**TOWN OF NEWBURGH  
PLANNING BOARD  
TECHNICAL REVIEW COMMENTS**

**PROJECT NAME:** DARRIGO SOLAR  
**PROJECT NO.:** 19-24  
**PROJECT LOCATION:** SECTION 86, BLOCK 1, LOT 96  
**REVIEW DATE:** 26 JANUARY 2024  
**MEETING DATE:** 1 FEBRUARY 2024  
**PROJECT REPRESENTATIVE:** ARDEN CONSULTING

Subject: Darrigo Solar Farm Landscape Plan Comment Response Memo  
Comments Received by Email (Town Project Number 2019-14)

# AMENDED 5 MW AC SOLAR FARM SITE PLAN FOR DARRIGO 84 LAKESIDE AVENUE TOWN OF NEWBURGH – ORANGE COUNTY, N.Y.

**1 RESTORATION ALONG INTERSTATE 84 BUFFER**

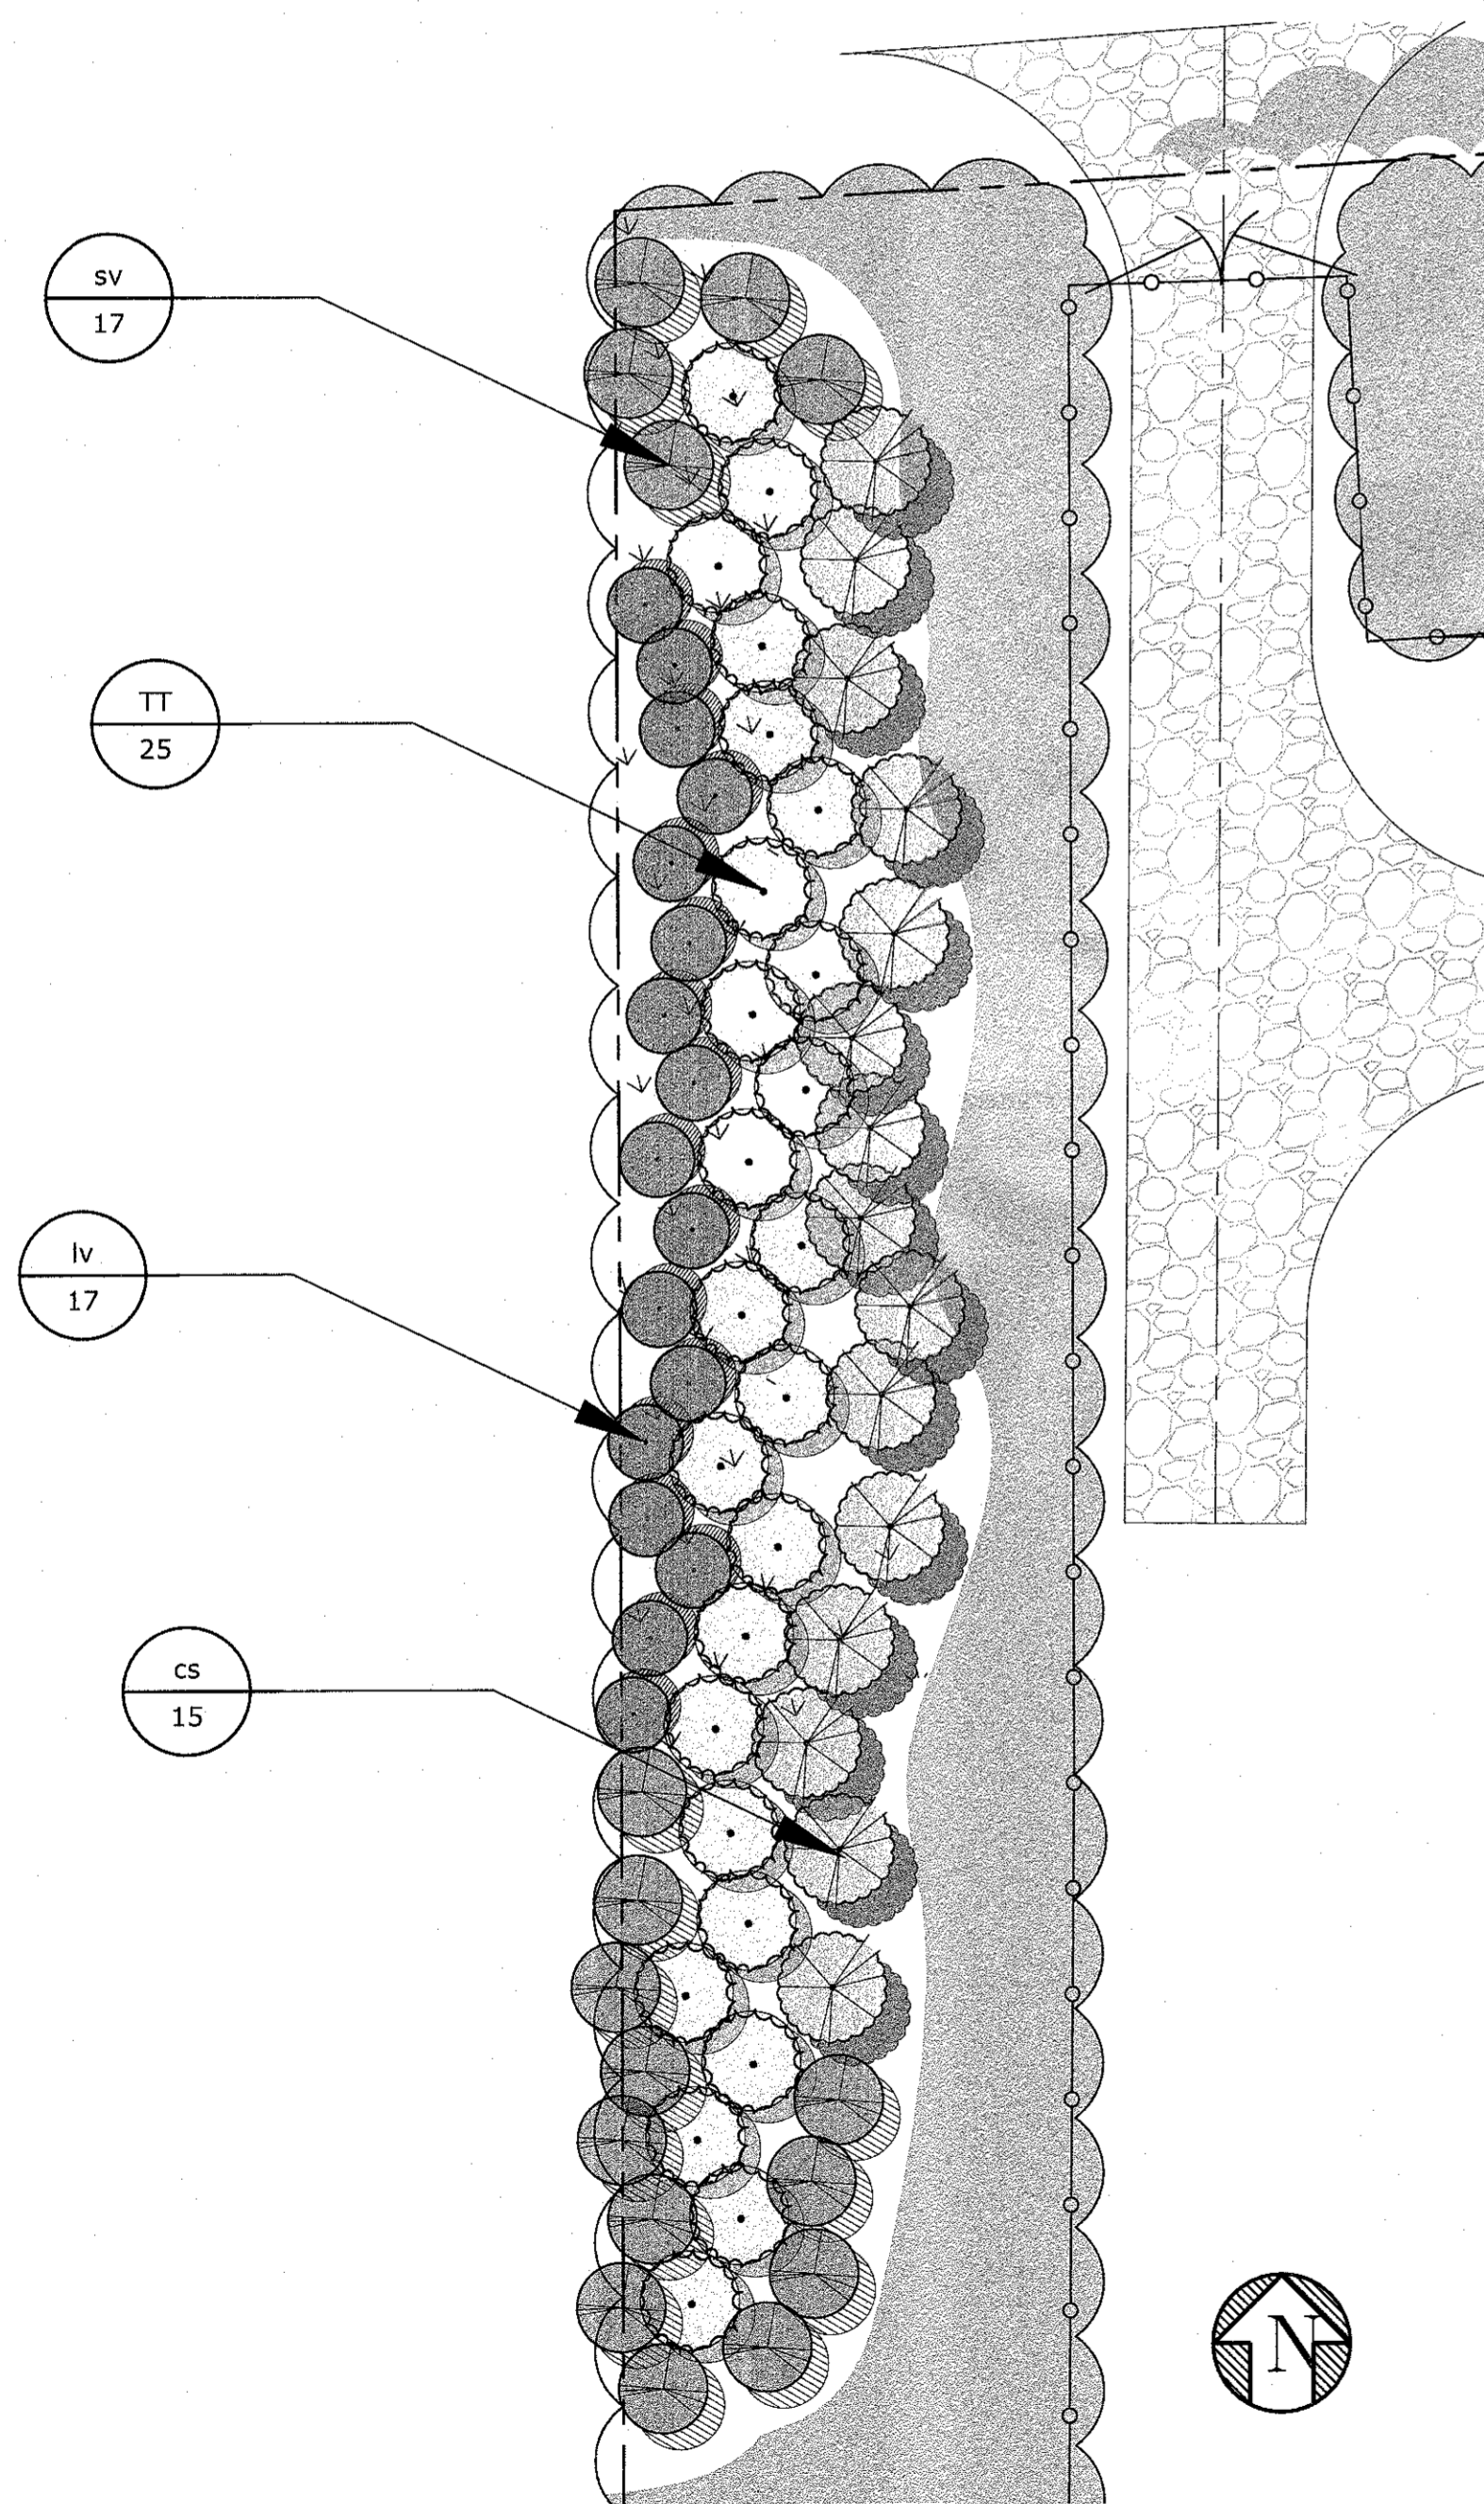
4. Deciduous screen planting is proposed along the property line adjacent to Interstate 84 as these plantings will blend in better with existing plants in the area. However, screening will be lacking come winter when the leaves have fallen so this should be discussed with the planning board. The size of the trees for proposed screening should also be discussed as all plants are small in size and will not be visible for quite some time.

**1 MEADOW HILL ROAD ENTRANCE PLANTING**

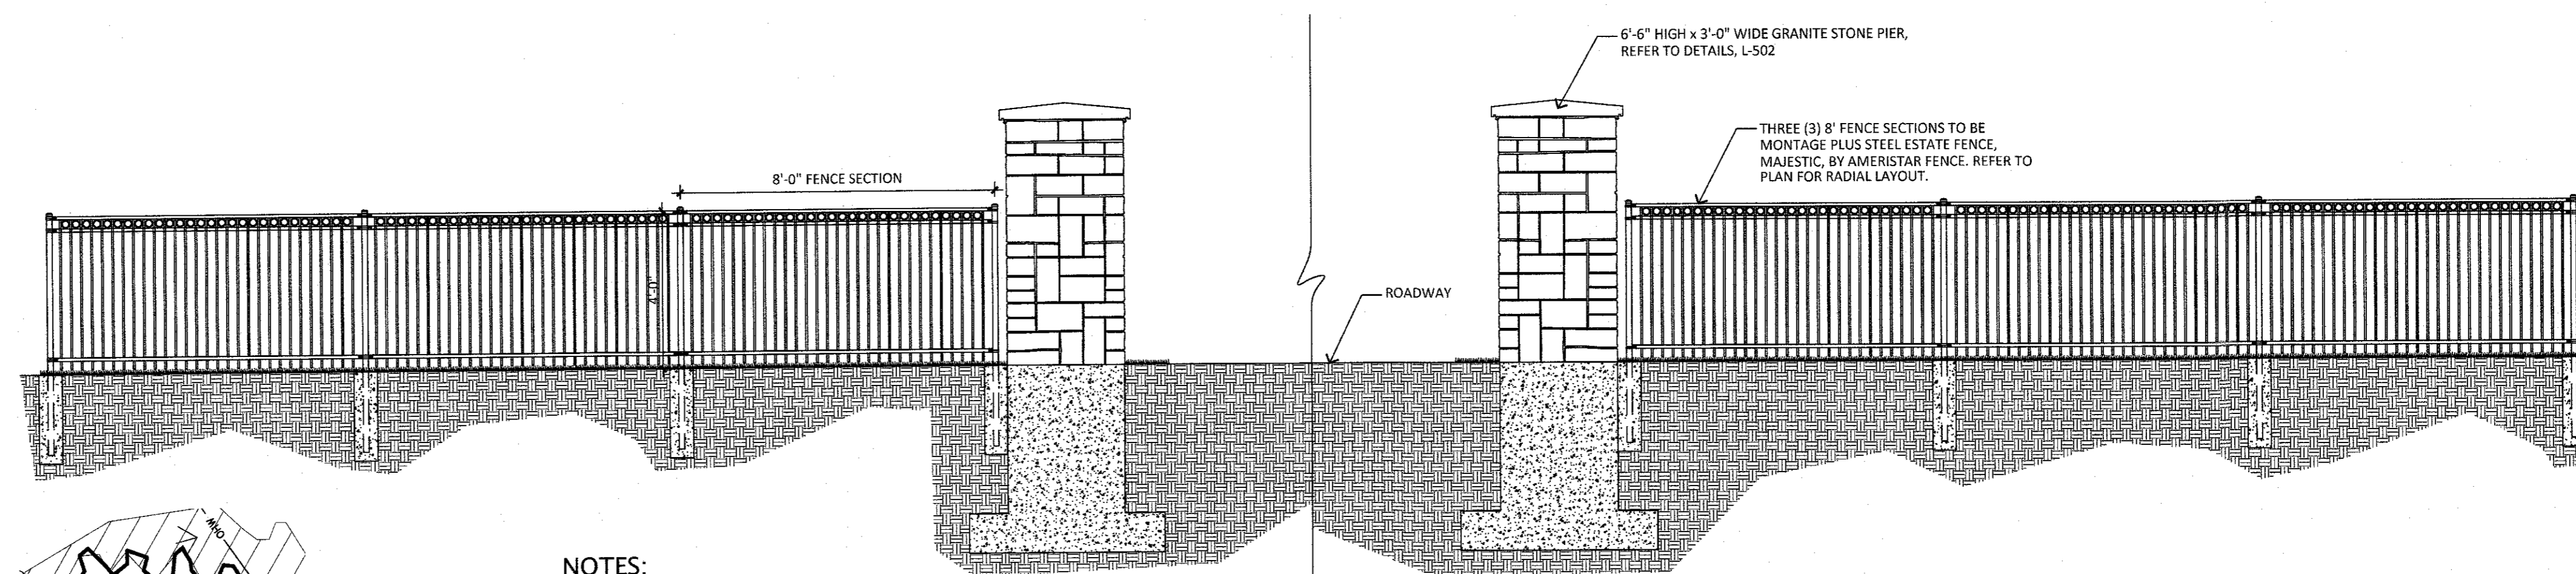
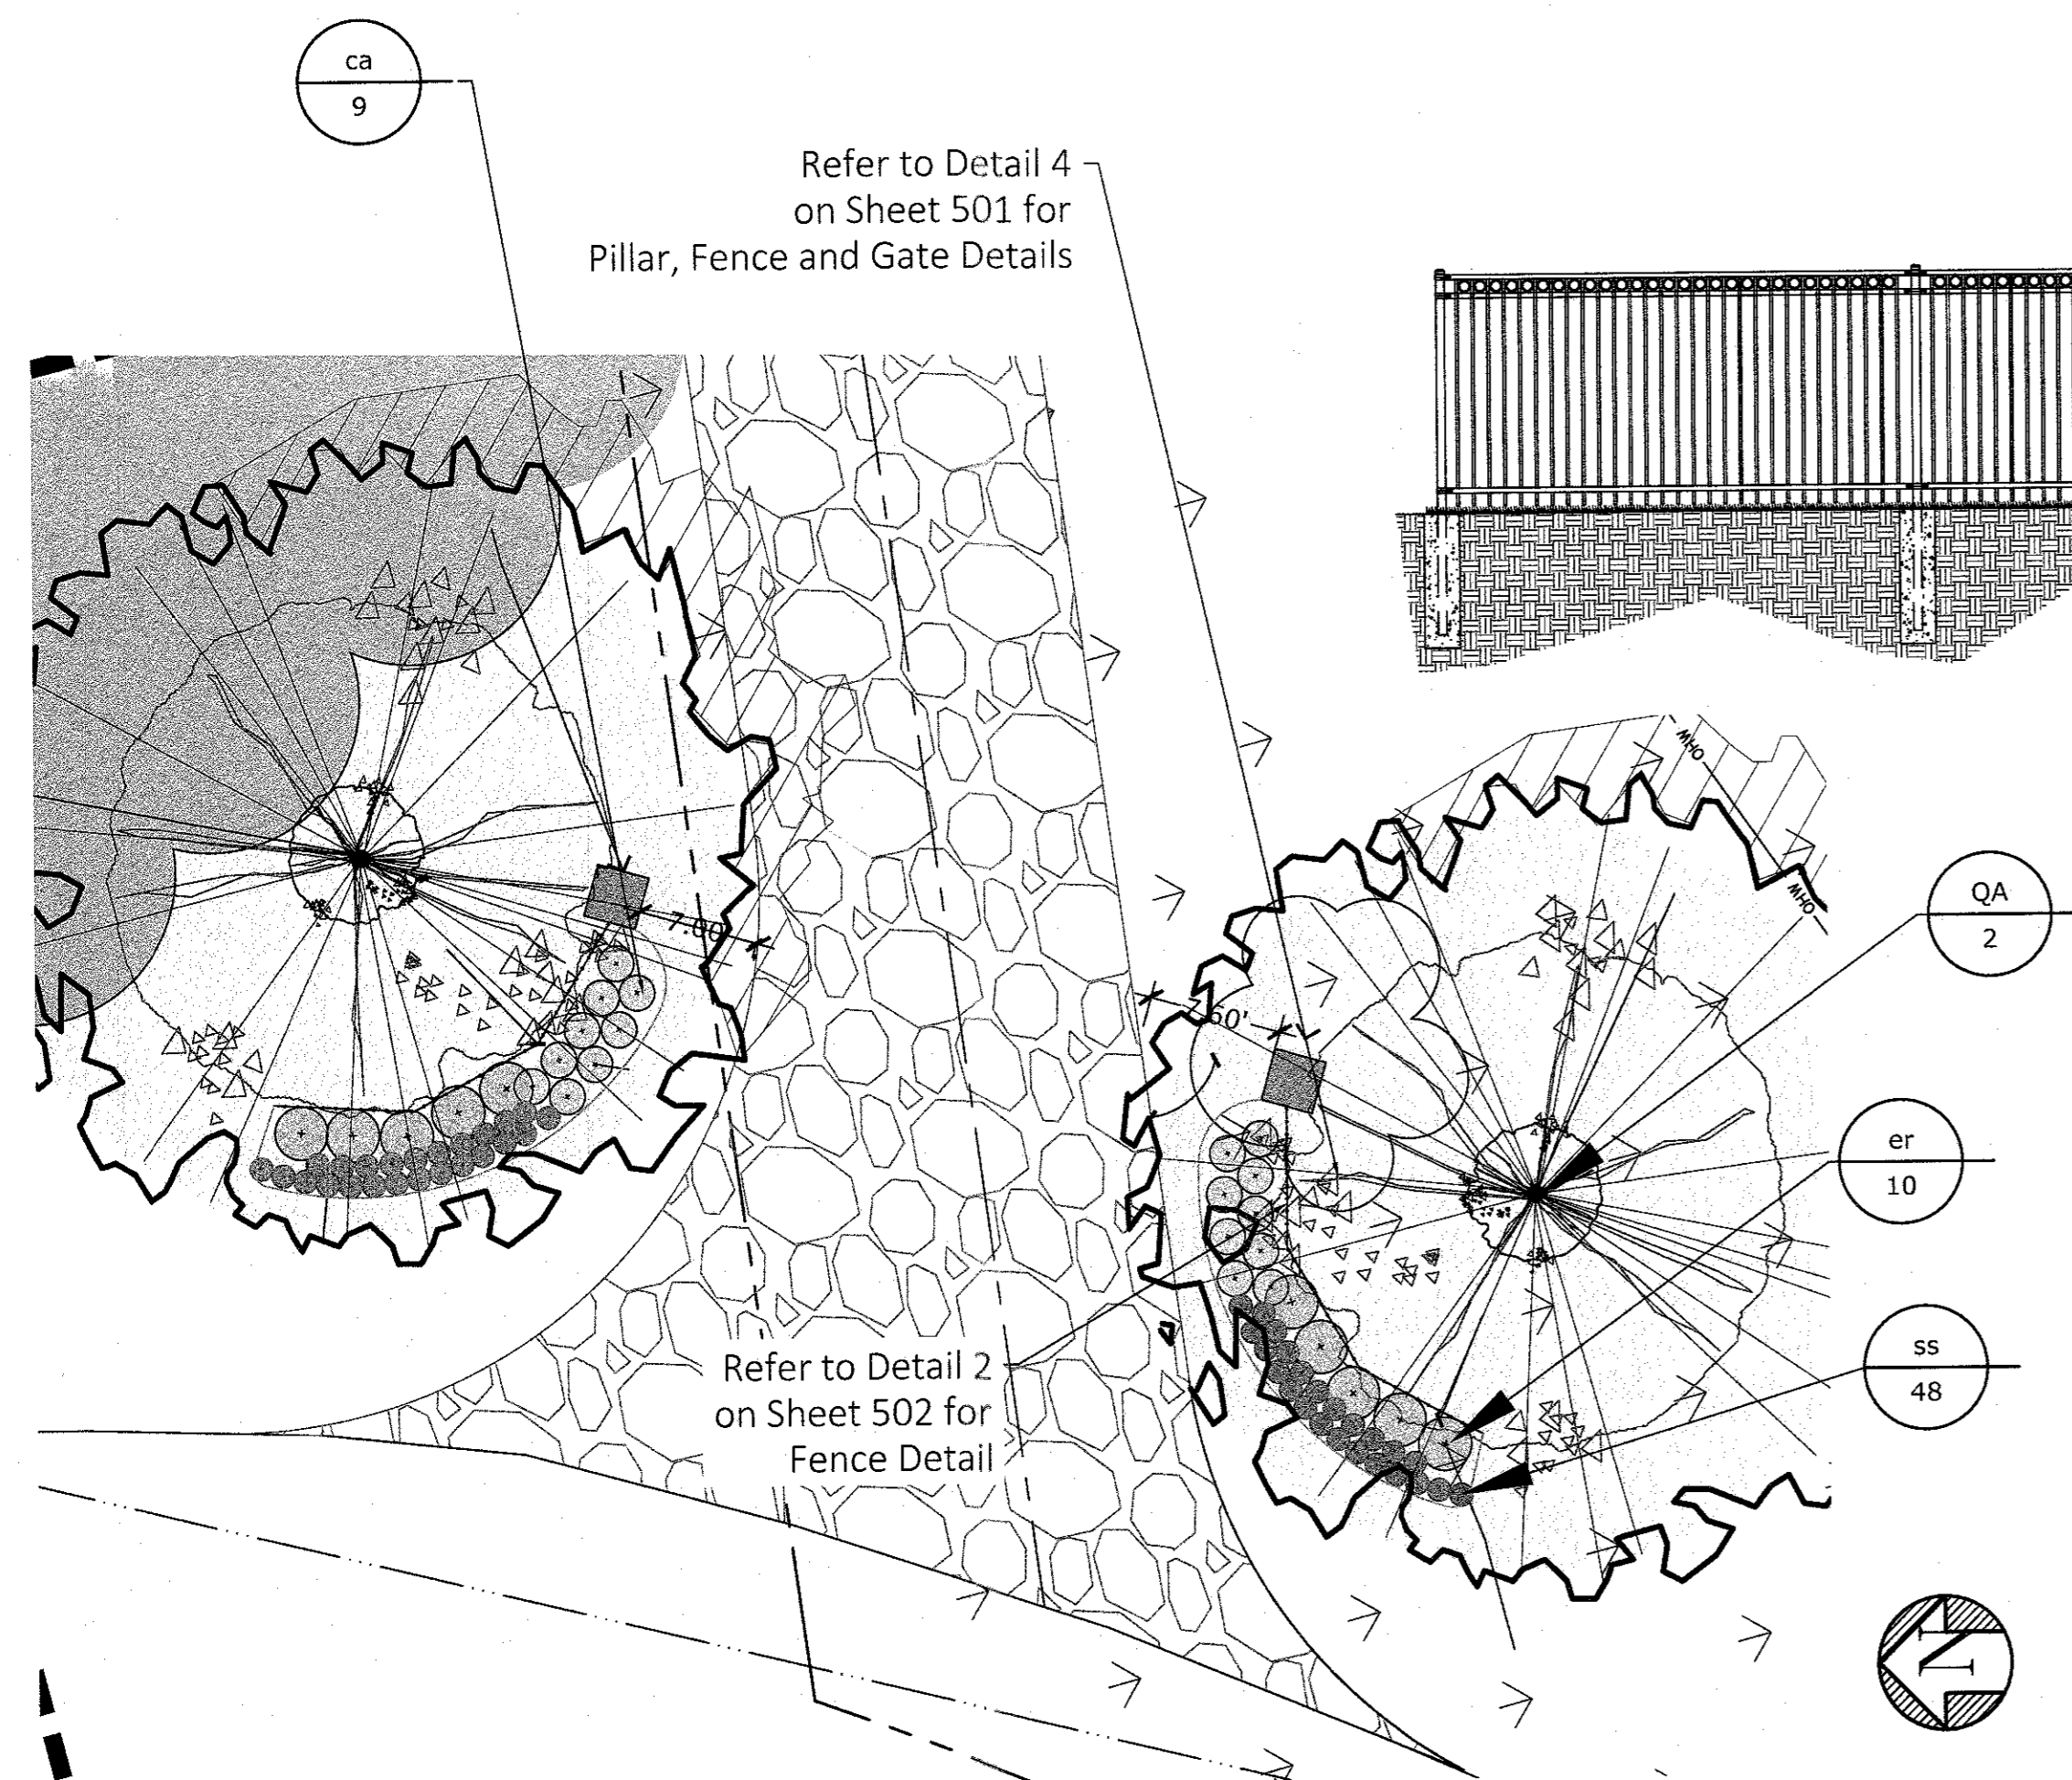
9. Please forward the enlarged planting plan so we can make sure this comment was addressed. Taxus x media has been removed from the planting plan and replaced with Ilex glabra. Enlarged planting plan has also been included in the updated plan set.

9. *Taxus x media* 'Nigra' has been proposed at the Meadow Hill Road entrance. *Taxus* is very susceptible to deer browsing. It is nice to have well-spaced evergreens but it would take decades for the *Taxus* to grow to the approximate mature plant size illustrated on the plan. For these reasons we suggest replacing them with a different evergreen. Also, when proposing mature spacing for shrubs, low growing plants or groundcovers should be specified to fill in and help prevent

**3 LAKESIDE ROAD ENTRANCE PLANTING**

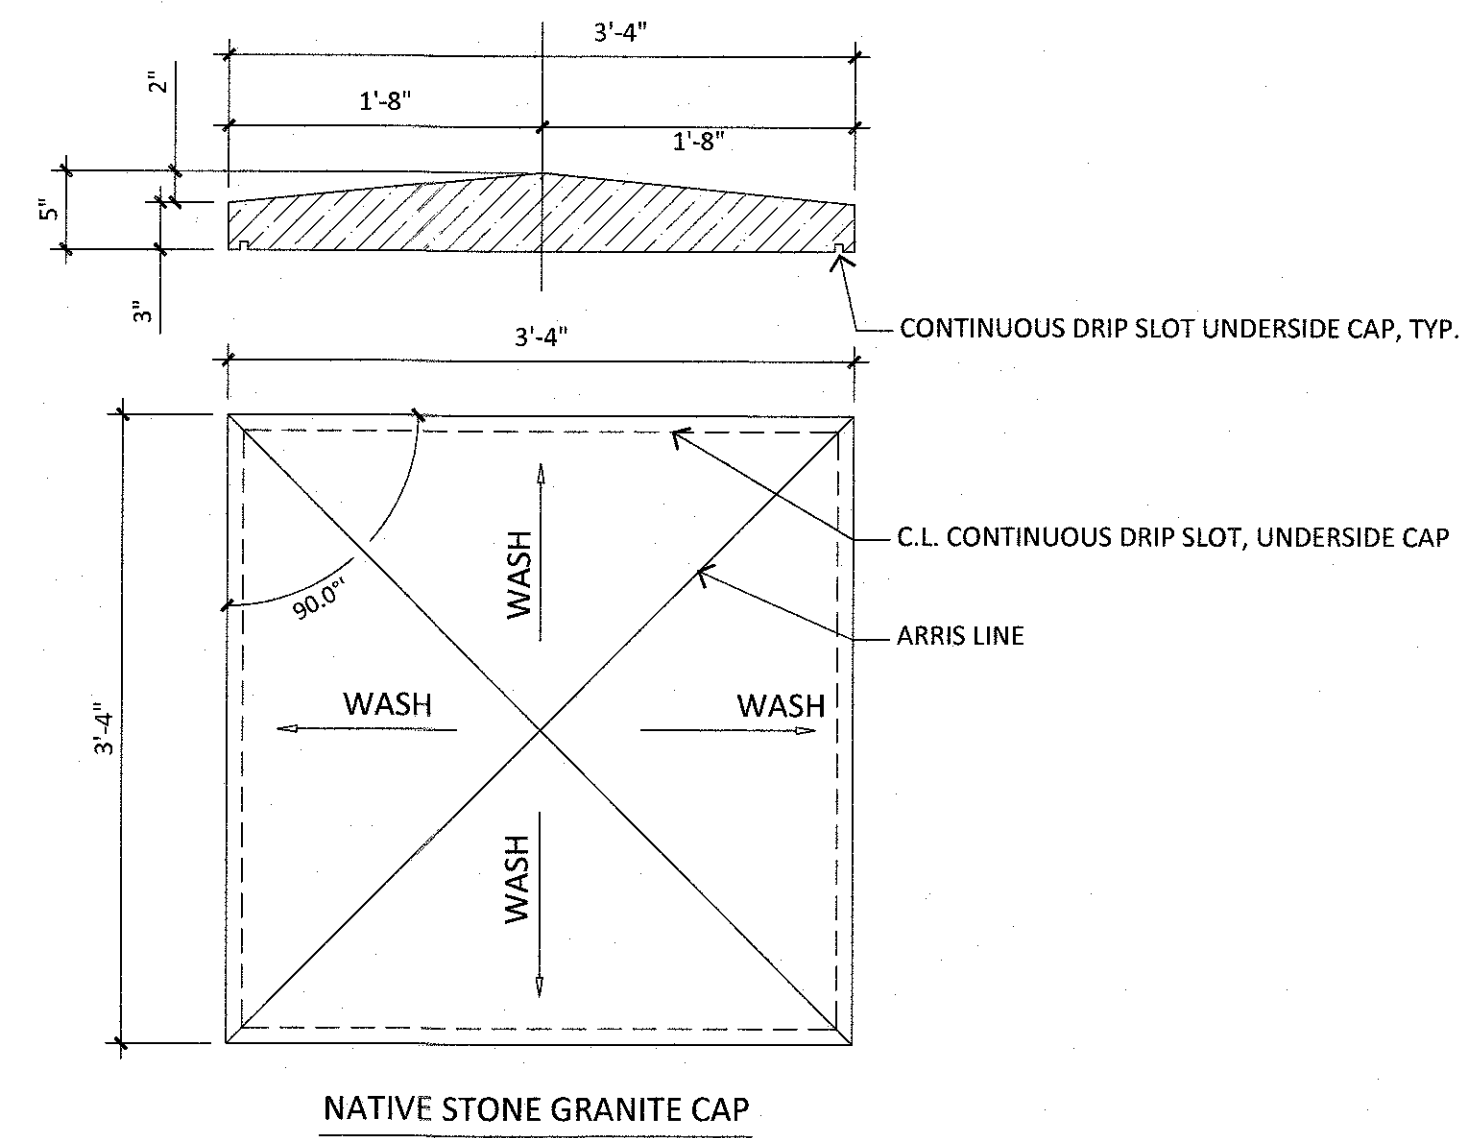
6. *Erianthus ravennae* has been proposed at the Lakeside Road entrance. It is a non-native plant which spreads from ornamental plantings along roadsides and other disturbed edge habitats and has been reported as invasive in Western, Midwestern, and Southern states, as near as Ohio and Maryland. Please consider using a native grass, or other grass without reported invasive tendencies.
